37/03-03A 7128 Carroll Avenue
(Takoma Park Historic District)

SUBJECT: Historic Area Work Permit 37/3-03A

HISTORIC PRESERVATION COMMISSION STAFF REPORT

Address:	7128 Carroll Avenue	Meeting Date:	01/08/03
Applicant:	Guy Rene (Fred Lamour, Agent)	Report Date:	01/01/03
Resource:	Takoma Park Historic District	Public Notice:	12/31/02
Review:	HAWP Retroactive	Tax Credit:	No
Case Number:	37/03-03A	Staff:	Corri Jimenez
PROPOSAL:	Window replacement	RECOMMEND:	Denial

Front view (2002)

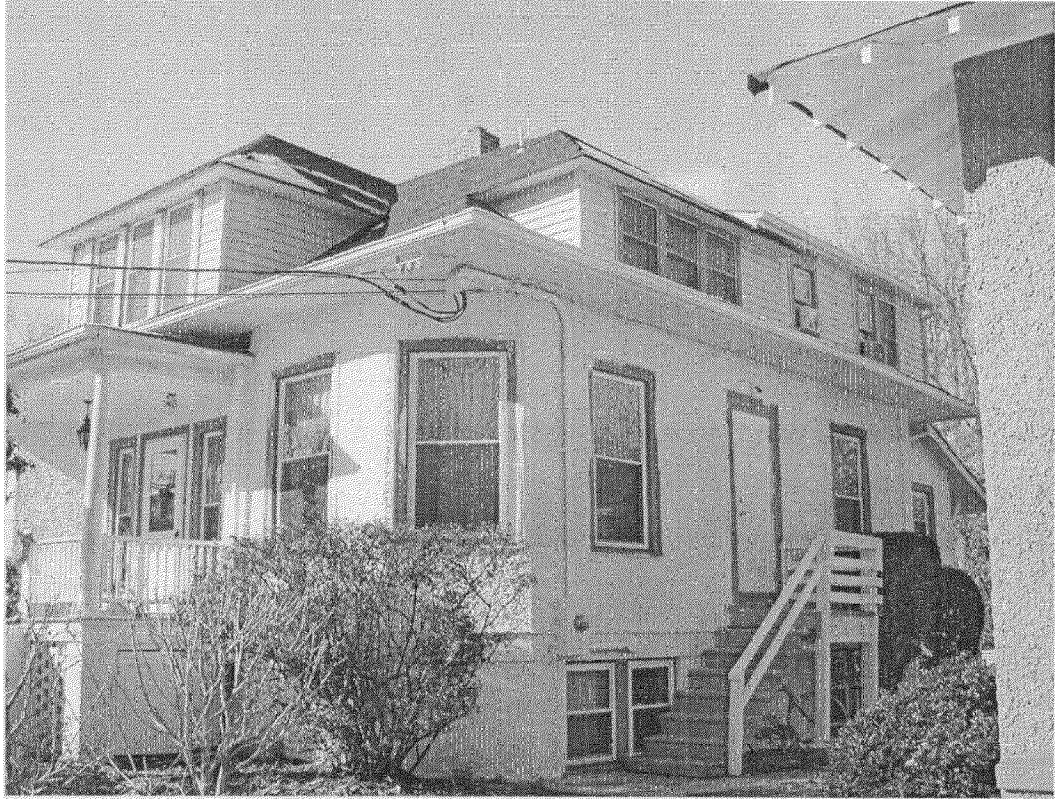
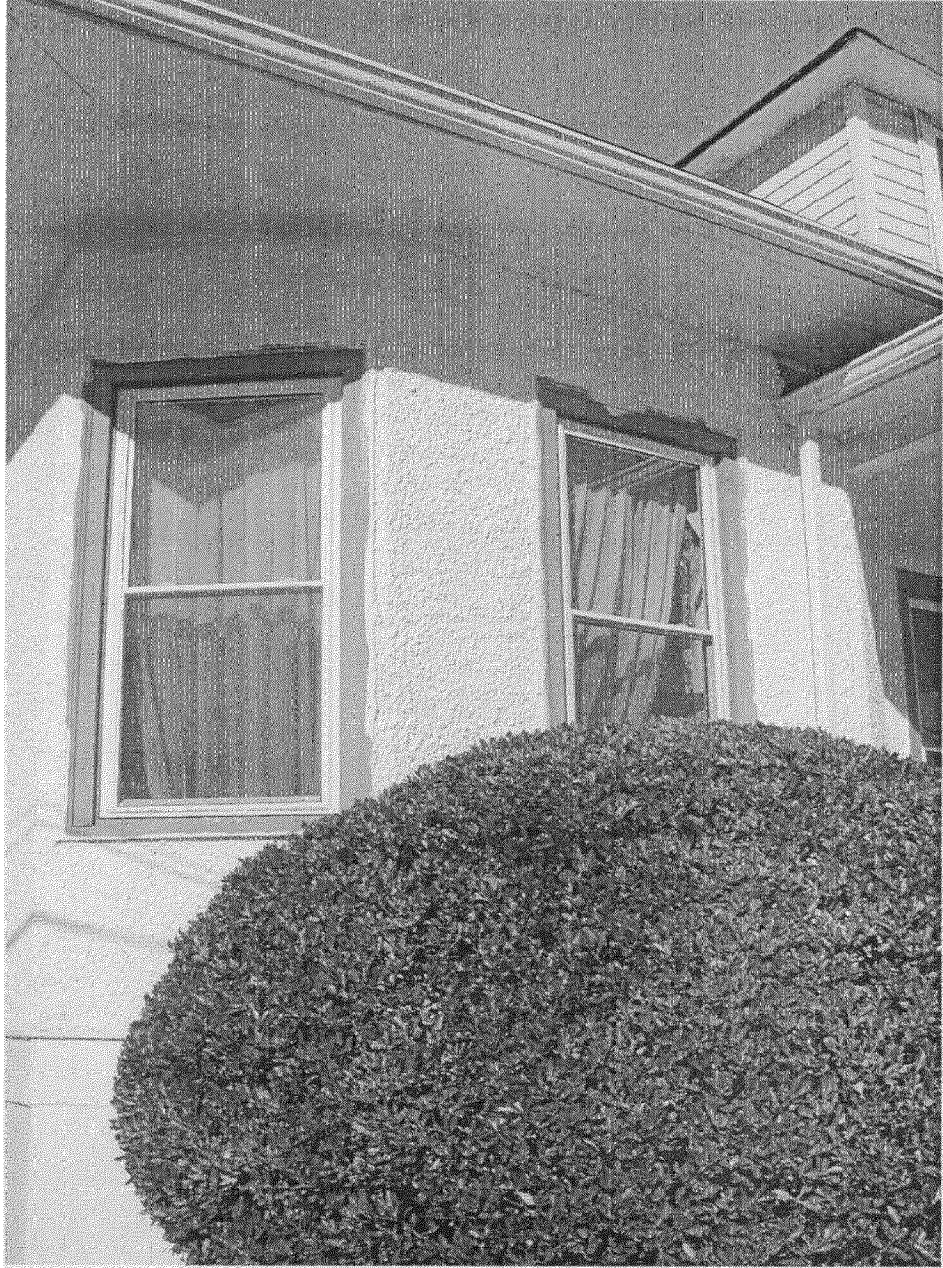
7128 Carroll Avenue is a contributing resource to the Takoma Park Historic District. It is a 1-½ story Craftsman bungalow with a central hip roof dormer. Wide eaves with an Oriental influence swoop from the roof and are character-defining features of the house.

Staff recommends denial of the retroactive application since the new vinyl windows are not appropriate for a contributing resource in the Takoma Park Historic District.

Staff further recommends that the applicant be directed to replace the vinyl windows with appropriate wooden, double hung windows that match any remaining, historic windows with the window to be used approved at a staff level.

Ellison Windows & Doors – Product from website

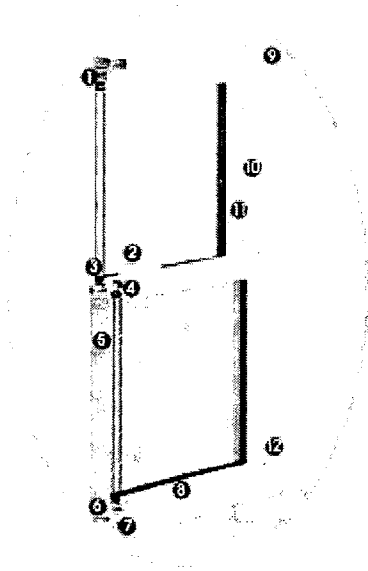
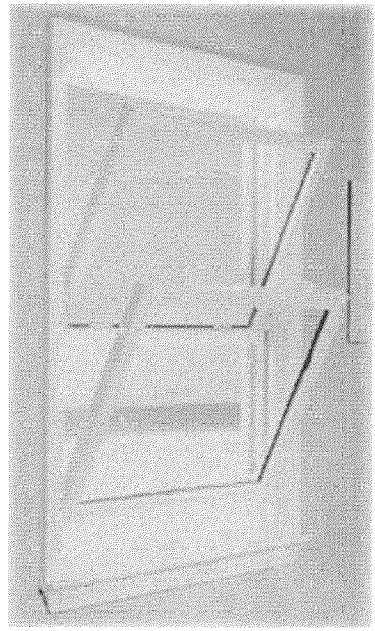
In early November 2002, the applicant removed original windows and installed 33 vinyl, Ellison 1300 double hung windows (see Circle 13). The original windows, according to installer David Harvey, were “screwed, nailed, and caulked together and not functional” (see Circle 9). In addition, Mr. Harvey recorded the windows condition as “separated, split, broken and held together by metal...storm windows were missing many parts and on most of them, the glass was cracked.” The old windows were thrown away and are not retrievable.

In addition to the Secretary of the Interior's Standards and Guidelines, the Takoma Park Historic District has local guidelines that state, "some non-original building materials may be acceptable on a case-by-case basis" (see Circle 15). However, staff does not feel that this case is one in which this guideline should apply. The applicant undertook replacement of all windows without HPC review. This is a major change to a contributing resource and is counter to all previous HPC decisions on similar cases. Finally, the vinyl replacement window chosen is the worst solution from a preservation standpoint.
